Report: TAB REPORT
Function: Test, Adjust, & Balance
Date: 11/12/2024
Completed By: National TAB

PROJECT
10-28-24 WAWA #5412 PLANTATION, FL

Project Issue Information

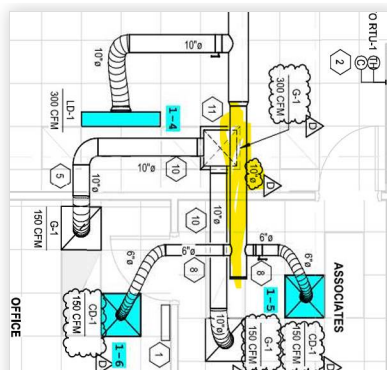
Issue Name : Diffusers 1-5 and 1-6 - Low Flow
Description : Diffusers 1-5 and 1-6 (Associates and Office) are currently outputting 119 CFM and 92 CFM, respectively (79% and 61% design). Dampers are fully opened. Airflow increases slightly when straightening flex duct. Recommend mechanical inspection.
Created By : National TAB **Assigned To :** National TAB - Will Turnbough
Status : Open
Priority : High **Asset Tag :** SGRD5
Originated Date : 10/29/2024 - Mark Johnson - National TAB

- **10/30/2024 National TAB - Mark Johnson**
 - Branch duct serving these two diffusers is undersized (8" - required is 10"). This is likely the cause of their low flow. Recommend installing correct duct size.

- **11/12/2024 National TAB - Stephen Tassinaro**
 - Duct size remains 8". No adjustments made to these diffusers.

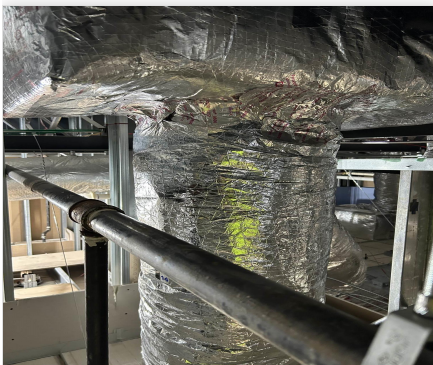
Issue Name : No Turning Vanes
Description : There are no turning vanes installed in the supply drops for any of the 3 RTUs.
Created By : National TAB **Assigned To :** National TAB - Will Turnbough
Status : Open
Priority : Urgent **Asset Tag :**
Originated Date : 11/11/2024 - Stephen Tassinaro - National TAB
